# UNITED STATES PATENT AND TRADEMARK OFFICE

10/032,959

<p align="center"><b>Office Action Summary</b></p>	<p>Application No.</p> <p align="center">10/032,959</p>	<p>Applicant(s)</p> <p align="center">LANDERS ET AL.</p>	
	<p>Examiner</p> <p align="center">Sean P. Shechtman</p>	<p>Art Unit</p> <p align="center">2125</p>

### DETAILED ACTION

FIG. 55A

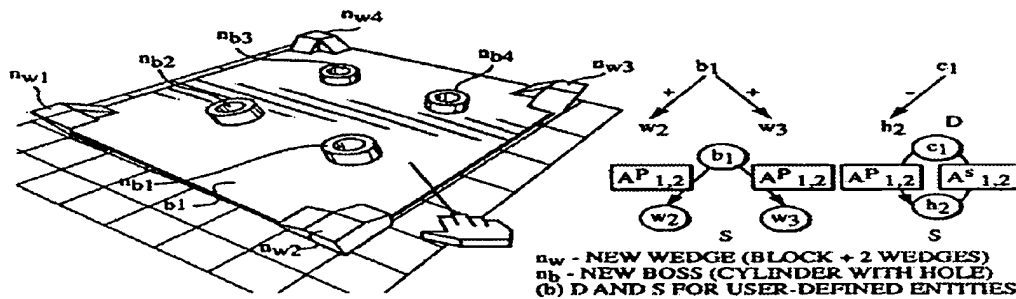
Gadh clearly teaches a design intent graph (D) used to create a design and record the specified design constraints to be used in future design activities. Clearly, D refers to the intended/desired geometric relations between the models features (Col. 20, lines 56-65). Gadh clearly teaches exemplary embodiments of a “machined part constructed in VDSF” with its corresponding D (Col. 36, lines 28-34).

Clearly, the D depicted above, is horizontally structured. The virtual blank is element b1, and a manufacturing feature could clearly be any of nw or nb with exclusive relationships to b1. Gadh clearly teaches elements as add-ins, wherein, as mentioned above, the figures depict “a machined part constructed in VDSF”. Gadh clearly shows the manufacturing features on a grid coordinate system. Furthermore, Gadh clearly teaches a child element (which can clearly be interpreted, without question, as any of the nw or nb elements) has an associative relationship with the coordinate system. The VDSF display viewed by the user is considered as having a right-left/top-bottom/front-rear coordinate system, whereby the user issues intuitive commands for a user-viewpoint-dependent method of alignment of said child element. And, Gadh also

clearly teaches that VDSF determines the XYZ coordinate axes when a viewpoint-dependent alignment command is issued (Col. 24, lines 6-32). Furthermore, Gadh teaches the representation can be implemented in any conventional 2D-CAD systems or VR-CAD systems utilizing VE (Col. 39, lines 33-44). Examiner respectfully submits that “associative relationship” requires no further explanation and that it will be given its plain meaning as required by MPEP 2111.01. Webster's Dictionary defines associative as “of, or relating to, in association with” while relationship as “a state or character of being related... a natural or logical association between two or more things, connection.”
